**STATE OF NEW HAMPSHIRE  
INTER-DEPARTMENT COMMUNICATION**

**SUBJECT** Dredge & Fill Application  
Amendment  
Stratford, 41788  
**(DES#2019-03673)**

Forwarded herewith is a permit amendment request prepared by NH DOT for the Stratford 41788, (DES #2019-03673) project.

**41788 STRATFORD**  
**NFWF US-3 CULVERT REPLACEMENT**

SURVEYED BY:	NHDOT
WETLANDS BY:	NHDOT
DRAWN BY:	JFM
CHECKED BY:	PLB
SCALE:	AS NOTED
DATE:	10/27/18
OVERALL SITE PLAN	
SHEET 1 OF 3

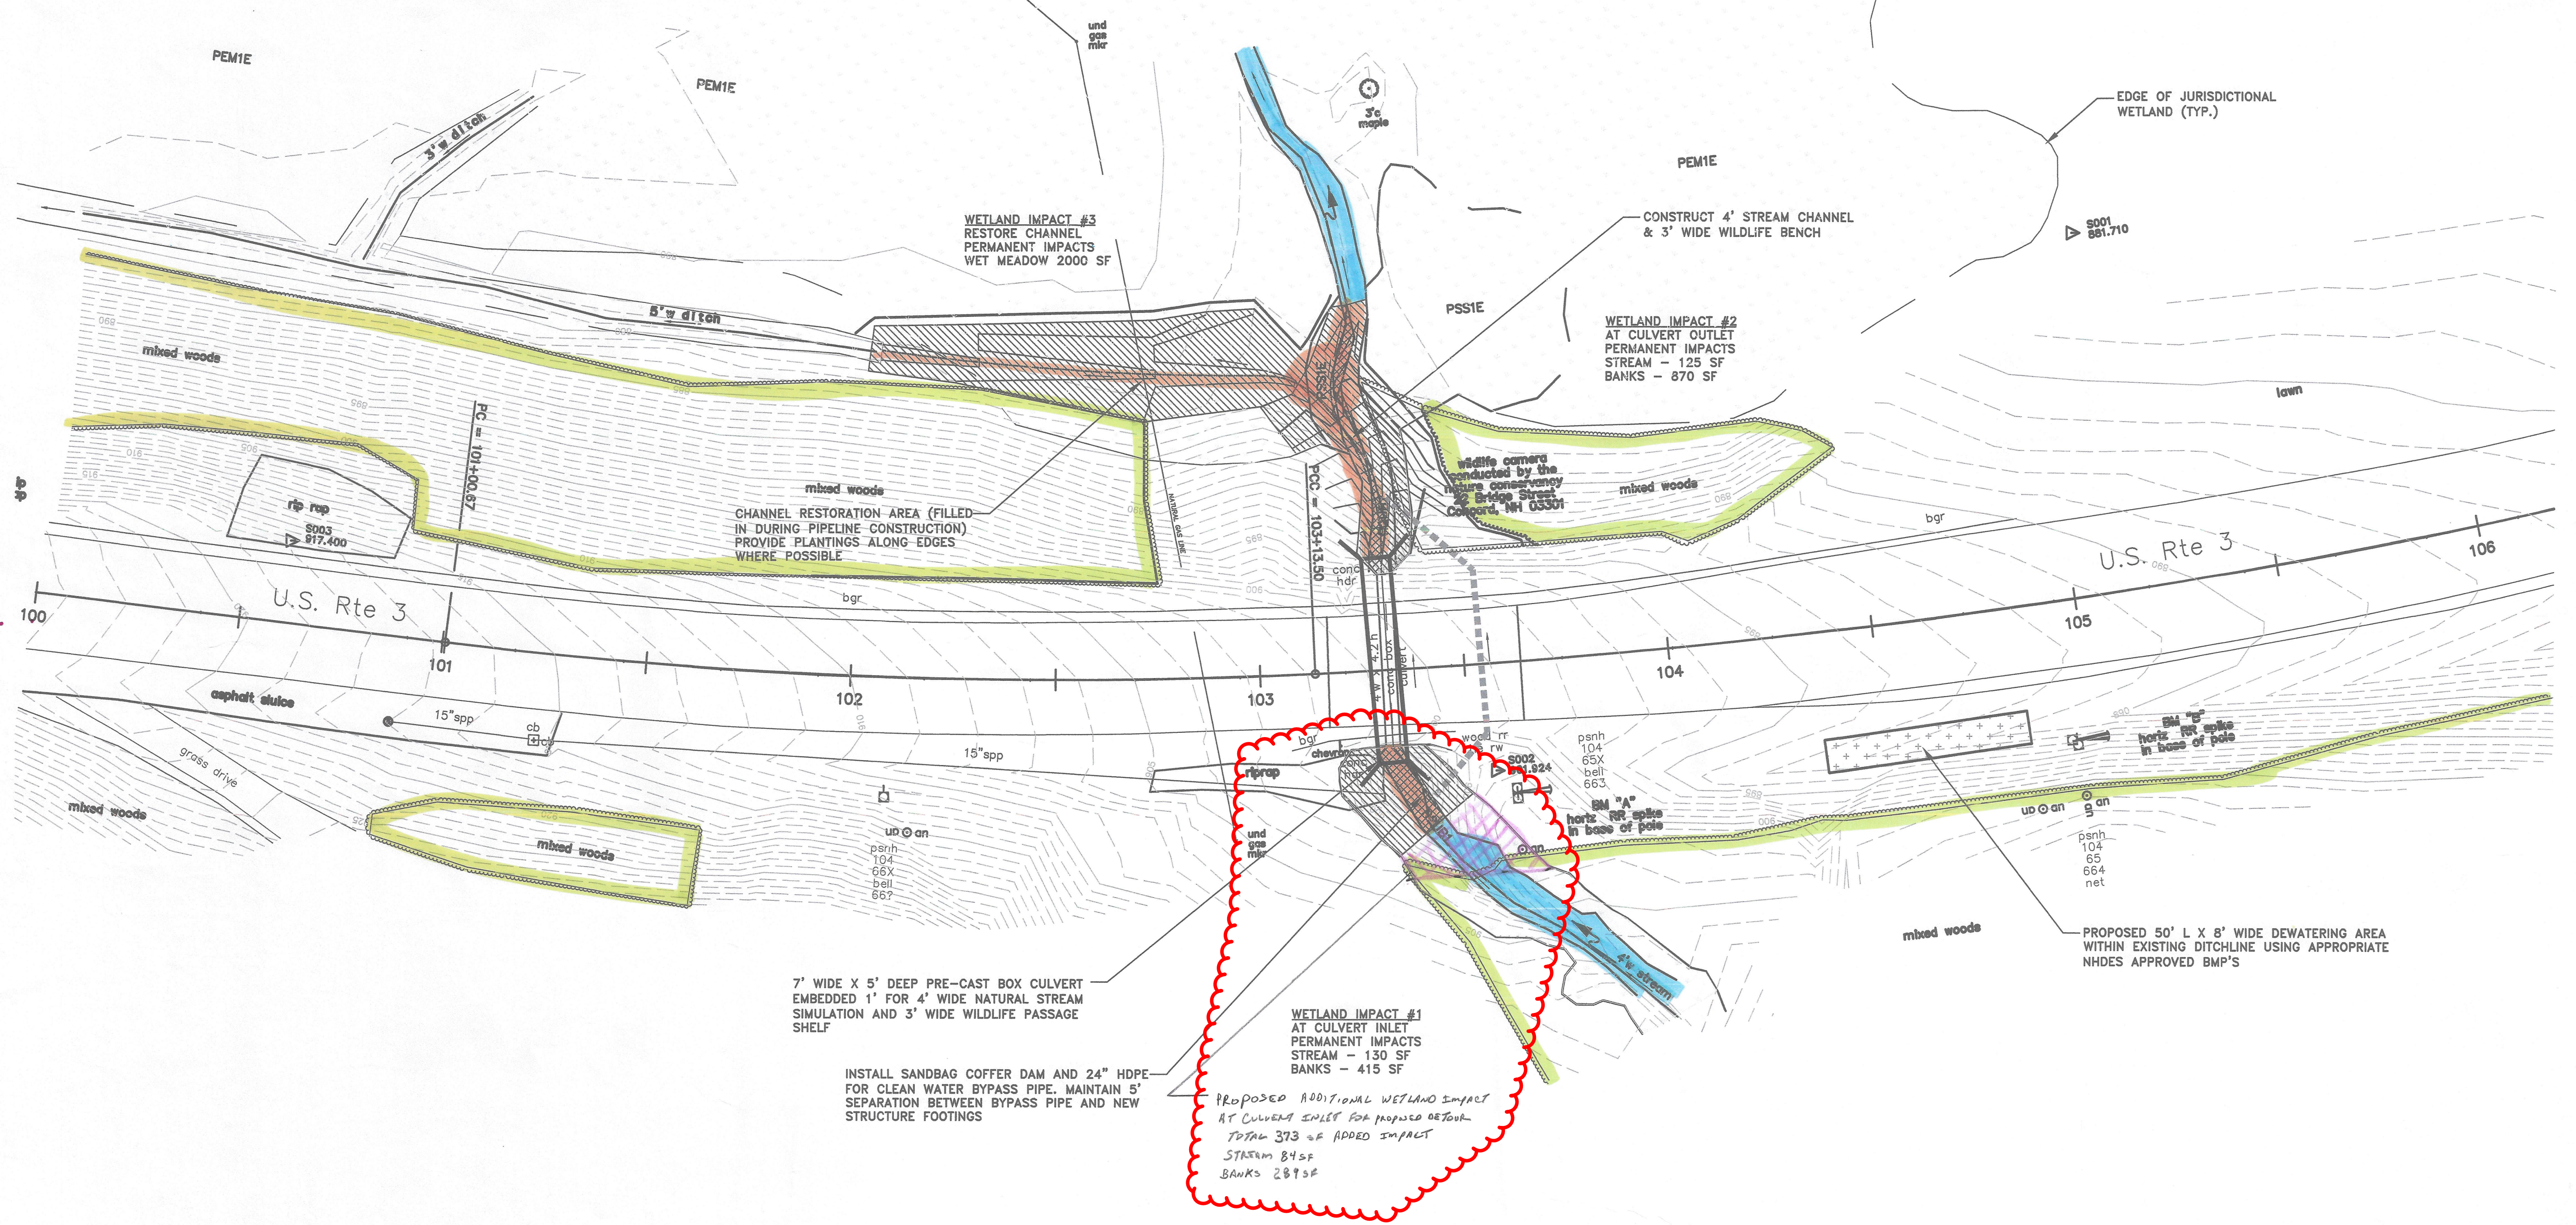
As District forces prepare to mobilize the project they determined that more space is need to facilitate two lane traffic along US Route 3 in Stratford, rather than the originally proposed alternating one-way traffic as US Route 3 is the primary travel ways in this area of the state. Therefore, NHDOT proposed to widen US Route 3 temporarily to the east, at the inlet of the culvert, which would temporarily impact an additional 373 SF of cumulative jurisdictional channel and bank at the inlet of the crossing to facilitate travel through this area during construction.

The previous permit impacted a total of 3,710 SF (3,540 SF permanent and 170 SF temporary). The amended design (see the purple shading on page 1 of the attached plans) impacts an additional 373 SF of temporary impact to stream channel and bank.

**PROPOSED ADDITIONAL WETLAND IMPACT AT CULVERT INLET FOR PROPOSED DETOUR**  
TOTAL 373 SF ADDED IMPACT  
STREAM 84 SF  
BANKS 289 SF
